Subject: C&D Landfill, Inc.

**MEMORANDUM**

RE: C&amp;D Landfill, Inc. (Pitt County, NC)

Pursuant to today's telephone conversation, this is to notify you of a recommended change in the monitoring well layout for the project. These locations represent a slight deviation from the tentatively approved locations on two wells, MW-2s and MW-4, relative to the map shown in the March 2001 Water Quality Monitoring Plan. The attached map shows the original and relocated well positions. The proposed changes will enhance the effectiveness of the monitoring program.

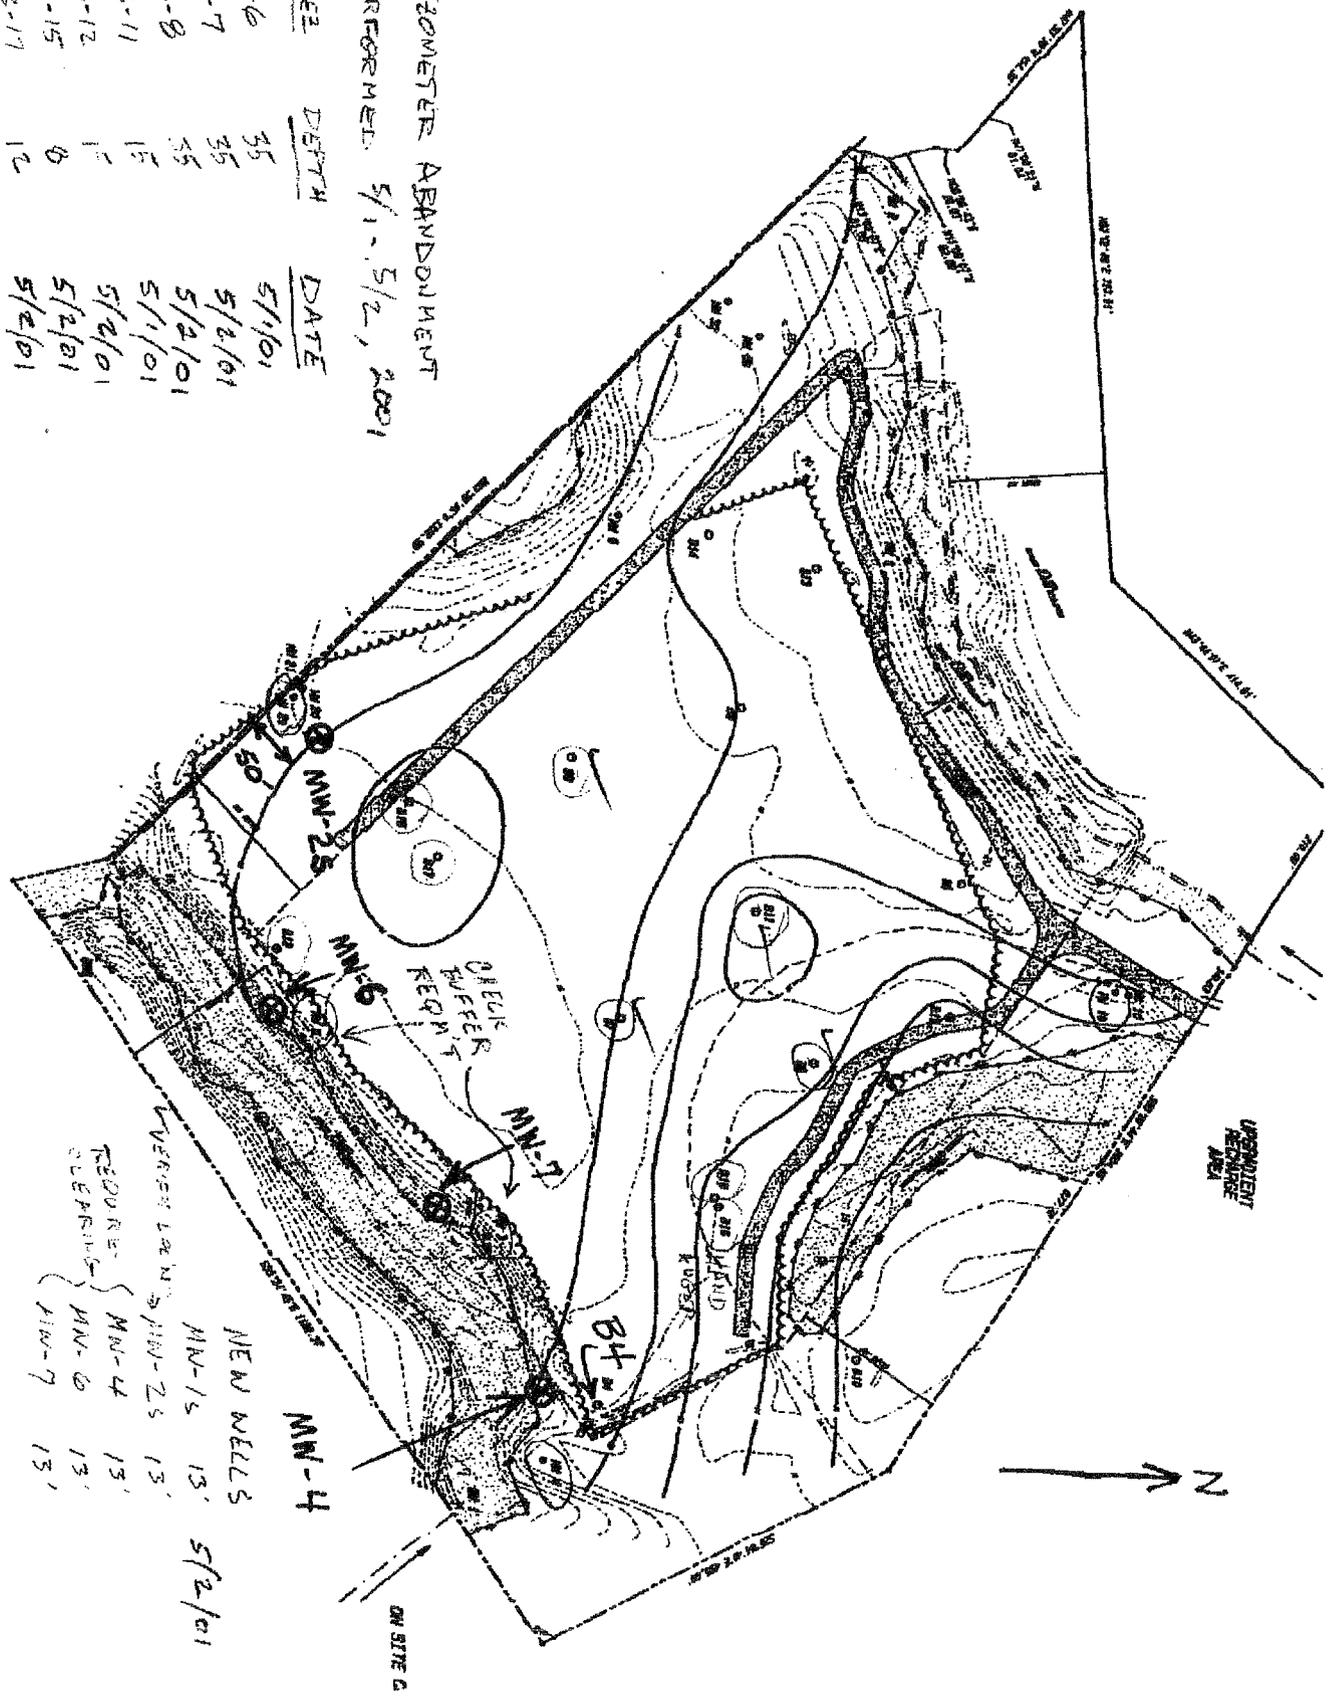
The proposed location for MW-4 was adjusted based on field conditions that do not show on the map. A shallow drainage feature, identified as a seasonal ground water discharge feature in the earlier submittal, exists southeast of the piezometer B-4. The original location of MW-4 was located across the seasonal drainage feature from the waste disposal area. It is my opinion that the well would be more effective for monitoring the uppermost aquifer if located on the west side of the drainage feature.

The location of MW-2s shown on the original map is adjacent to the property line. Regulations call for monitoring wells to be located at least 50 feet inside the property line. I propose moving the well east by 50 feet, to bring the well location in compliance with NC DWM regulations. The relocated well shall be approximately 150 feet from the waste boundary. The deeper well, MW-2d, will remain at its present location at the property line. It is my opinion that the location of the deeper well, which monitors the regional aquifer, is not as critical relative to the waste and property boundaries as the shallow wells.

The locations of MW-6 and MW-7 were adjusted to take advantage of prominent high ground extending into the wooded area, still observant of Tar-Pamlico riparian buffer requirements, which allows the wells to be located further back from the edge of waste than shown in the original plan map. The lateral separation from the waste boundary will be approximately 75 feet. These adjustments, along with the relocation of MW-4, keep the wells spaced approximately 300 feet apart, as determined appropriate by the contaminant transport equations.

This also to verify that all piezometers located within Phase 1A have been abandoned by over-drilling and pressure grouting, in accordance with North Carolina Water Quality and Solid Waste Standards. The attached map shows the piezometer locations and depths to which this work took place. The piezometers within Phase 1B were left in place and will be protected from damage for future water level observation. A formal certification will be prepared once the new wells are sampled, in pursuit of the Permit to Operate.
